Application Request: Consideration and action on final approval of Fenster Farms Phase 4 Subdivision, a three-lot subdivision.
Type of Decision: Administrative
Agenda Date: Wednesday, February 24, 2021
Applicant: Kenny Palmer, Representative
File Number: LVF06012020

Approximate Address: 560 N 5500 W, West Warren, UT, 84404
Project Area: 7.846 acres
Zoning: Agricultural (A-2)
Existing Land Use: Residential
Proposed Land Use: Residential
Parcel ID: 15-024-0015, 15-024-0016
Township, Range, Section: T6N, R2W, Section 07 SE

Exhibit A - Subdivision Plat

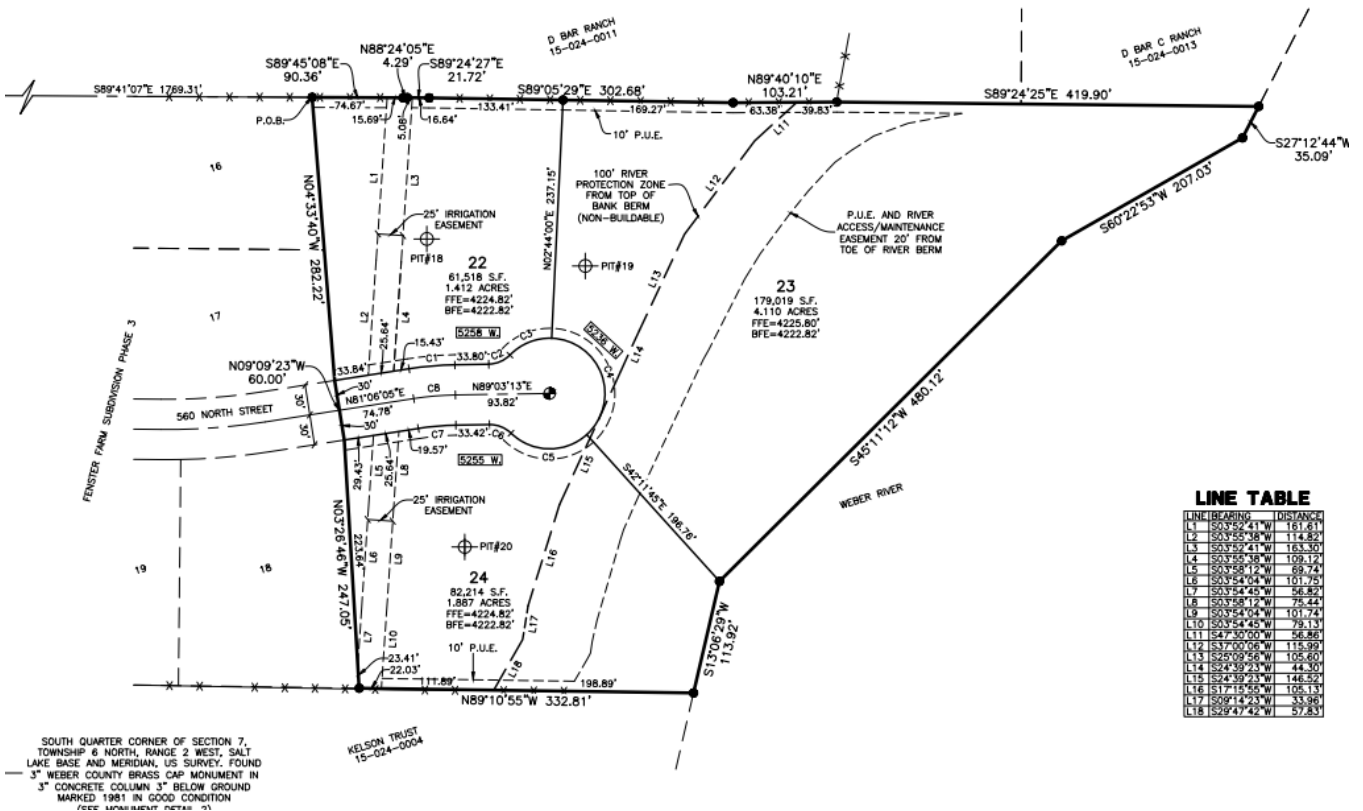
1. An escrow established for improvements to be installed, prior to recording the subdivision.
2. A 5' no-climb fence must be installed along both sides of the irrigation ditch to the west and south of the proposed subdivision.
3. Final approval from West Warren-Warren Improvement District must be obtained prior recording the subdivision plat.
4. A note shall be included on the final plat stating that no structures shall be constructed within any easements.
5. A 20' turnaround easement on the northern boundary and on the southern boundary, for the purposes of maintaining the ditch, shall be shown on the final plat.
6. A berm shall be shored up on either side of the irrigation ditch.
7. A gate shall be placed on the road sides of the ditch easement for maintenance access.
8. A 25' ditch easement shall be shown on the final plat.
